**STATE OF TENNESSEE
DEPARTMENT OF TRANSPORTATION**

INSTRUCTIONAL BULLETIN NO. 21-20

Regarding Various Revised, New and Voided Standard Drawings

Effective May 13, 2022 letting (March 2, 2022 Turn-in), the following Standard Drawings have been revised or are new. In addition, the Roadway Design Guidelines Chapter 7 – Item Numbers, Sections 7-611.00, Manholes, Catchbasins, Inlets and Pipe End Walls, and Section 7-705.00, Guardrails, of the Roadway Design Guidelines has been modified to reflect any changes to or new item numbers in the Standard Drawings of this Instructional Bulletin.

36" HEIGHT WALL WITH ALTERNATE REINFORCING

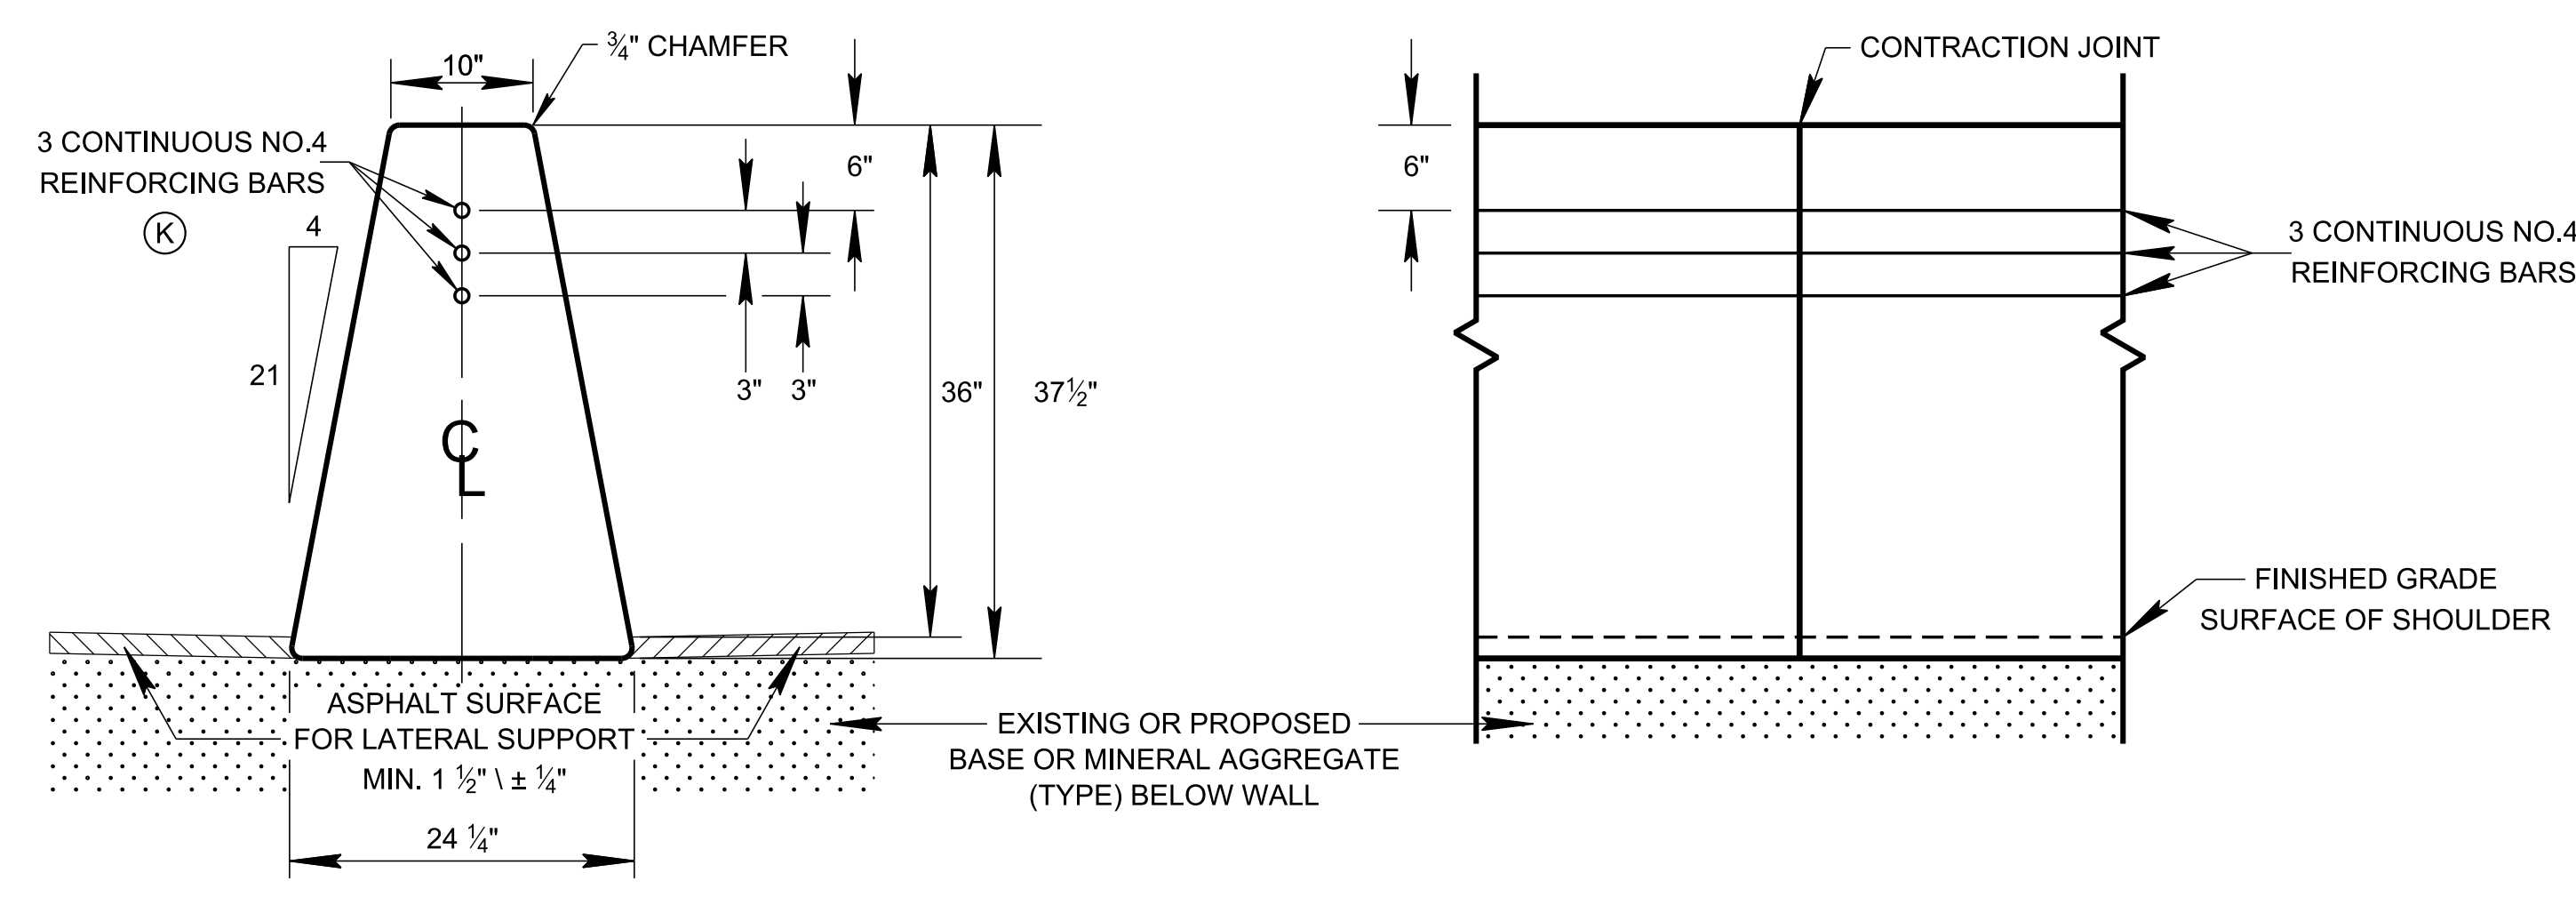
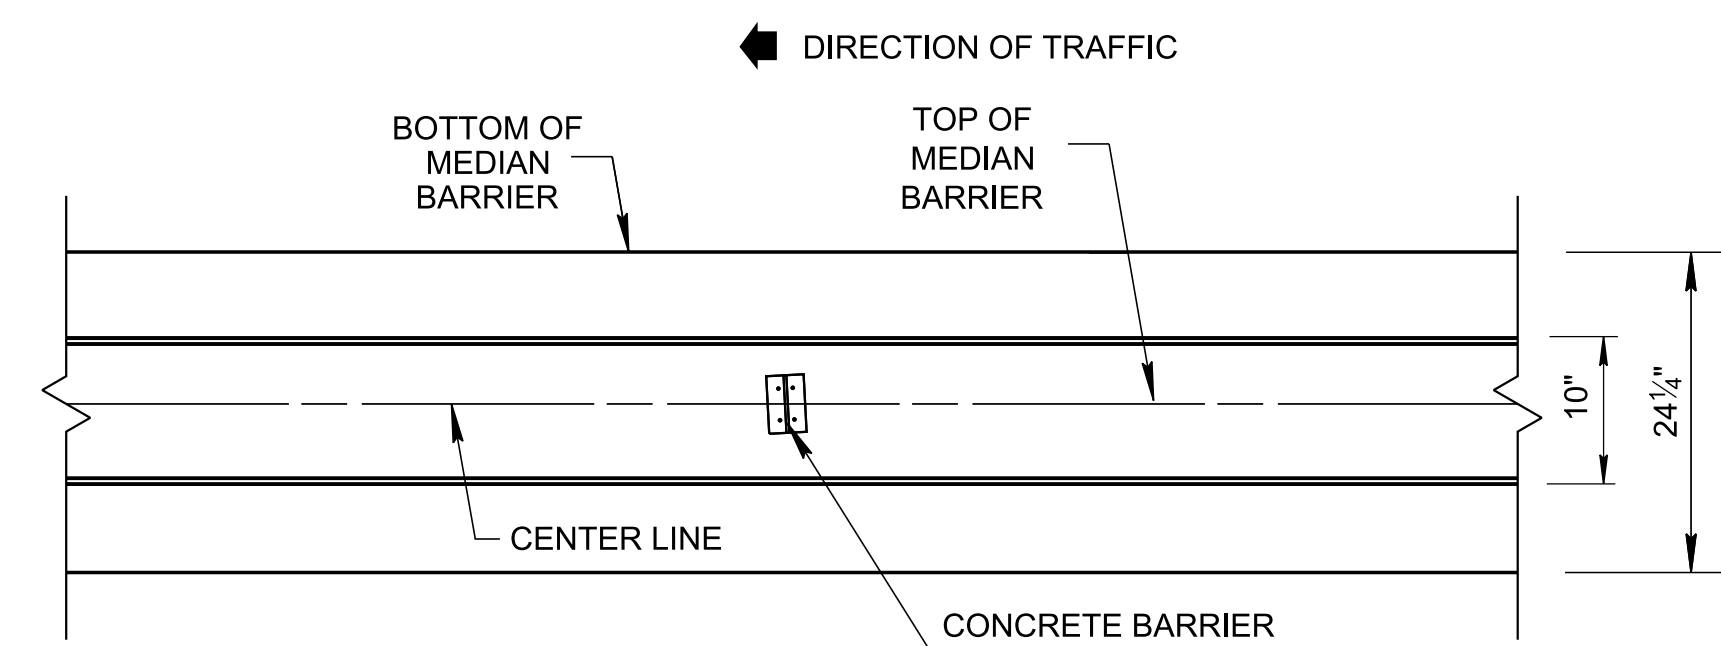
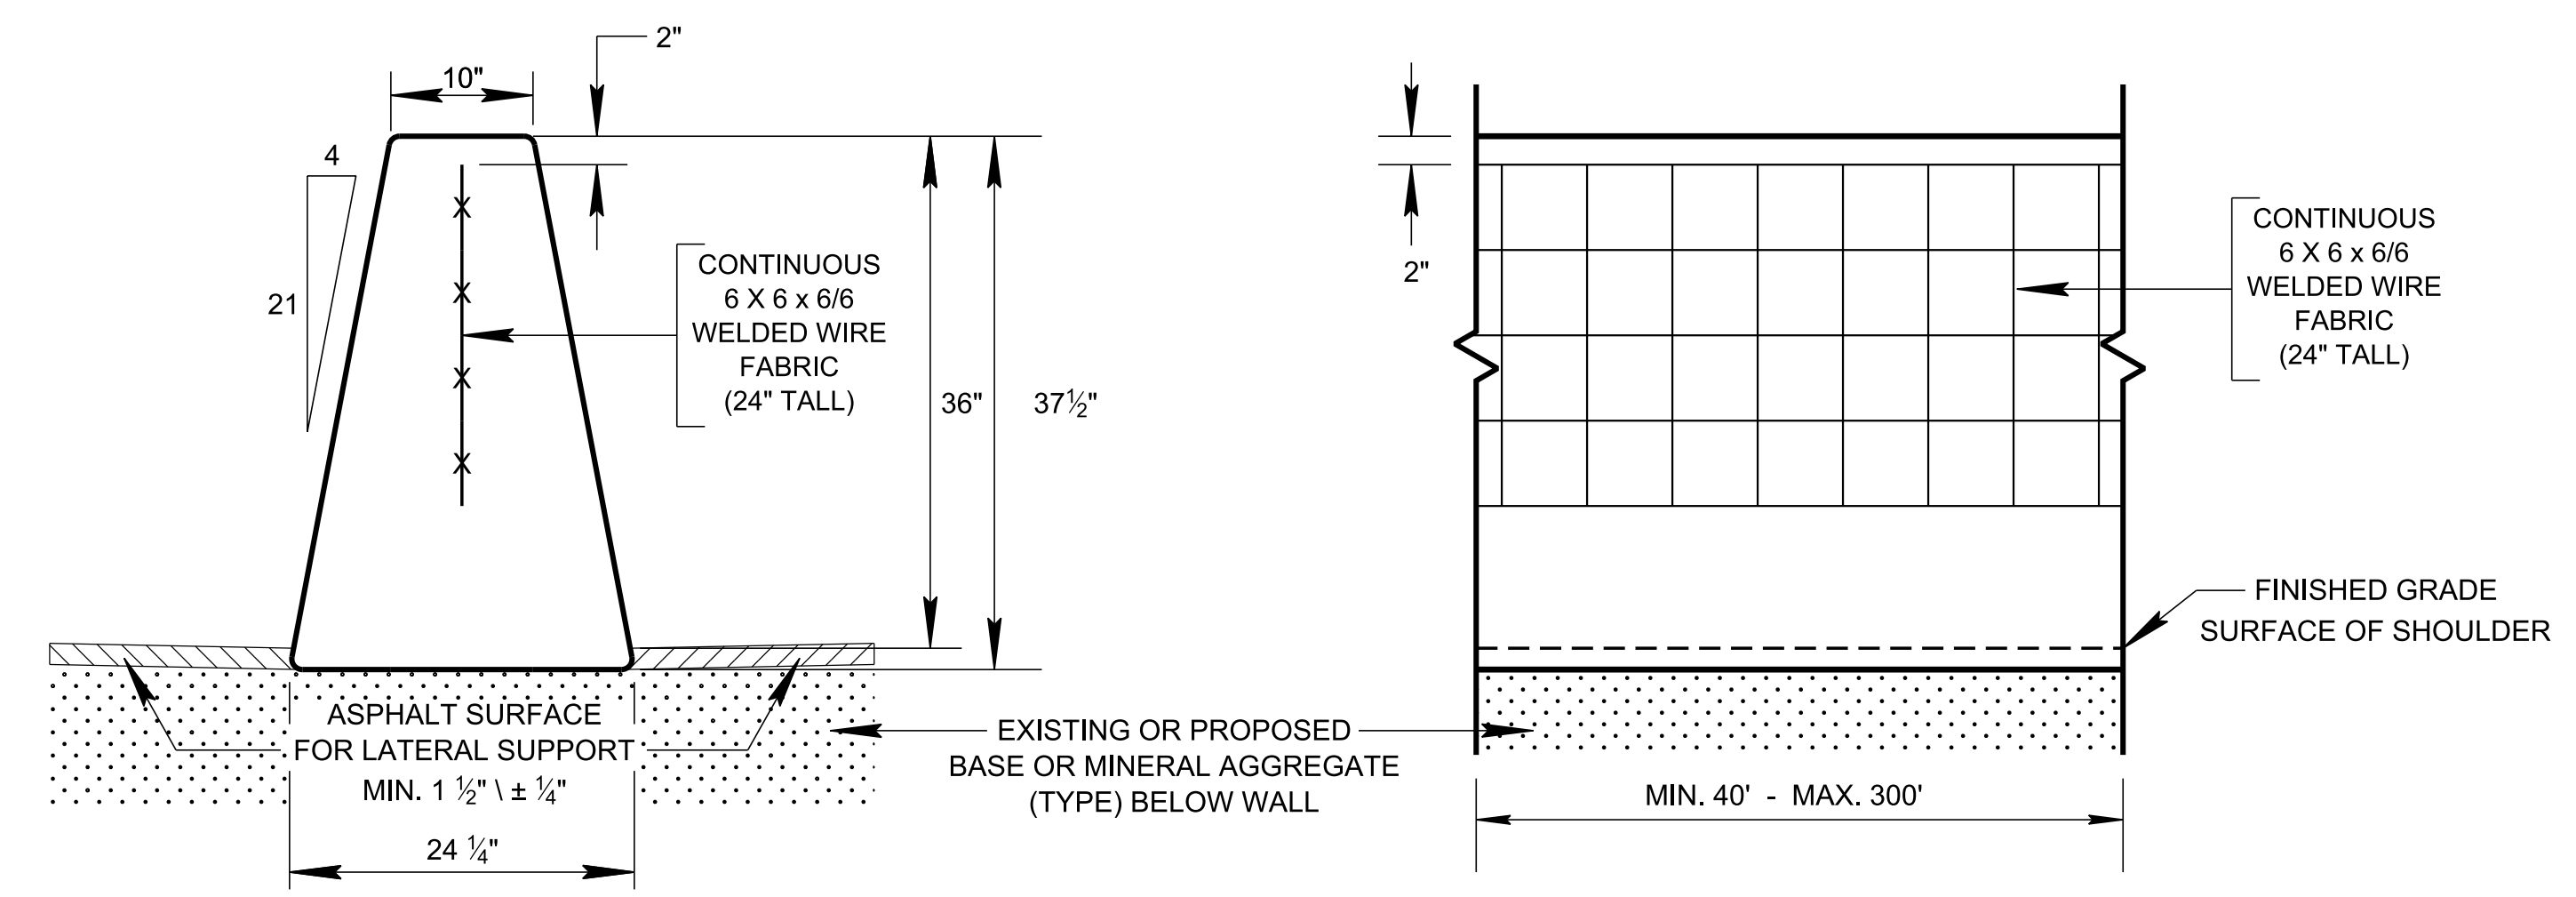
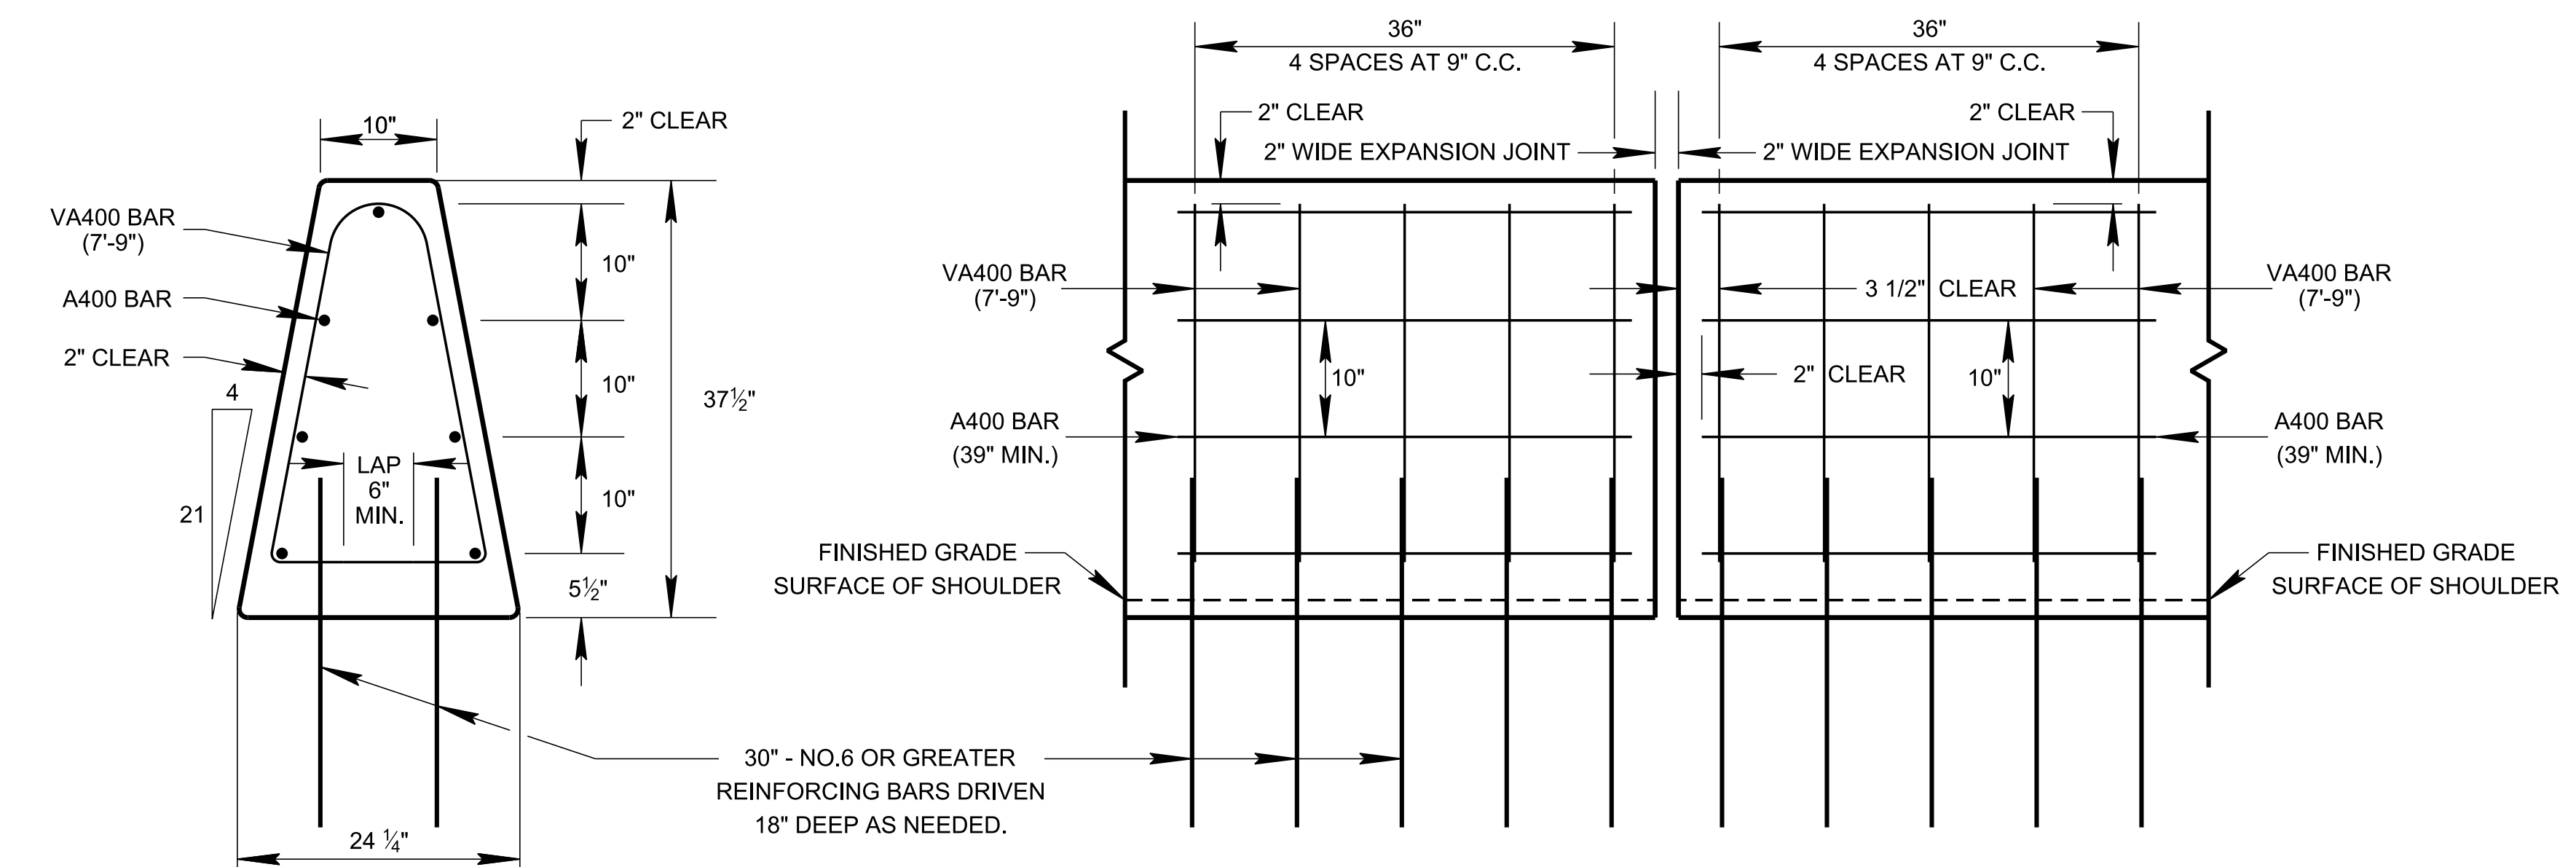
REV. 10-29-2021: DELINEATOR MOUNTING
 DETAIL AND DELINEATOR NOTES WERE
 REMOVED. ADDED GENERAL NOTE (L) FOR
 DELINEATOR MOUNTING DETAILS
 REFERENCE STD. DWG. AND PLAN VIEW.

- (L) REFER TO STANDARD DRAWING T-M-18A FOR MEDIAN BARRIER DELINEATOR MOUNTING DETAILS AND NOTES. THE COST OF FURNISHING AND INSTALLING MEDIAN BARRIER DELINEATORS SHALL BE INCLUDED WITH THE BID PRICE FOR CONCRETE MEDIAN BARRIERS.
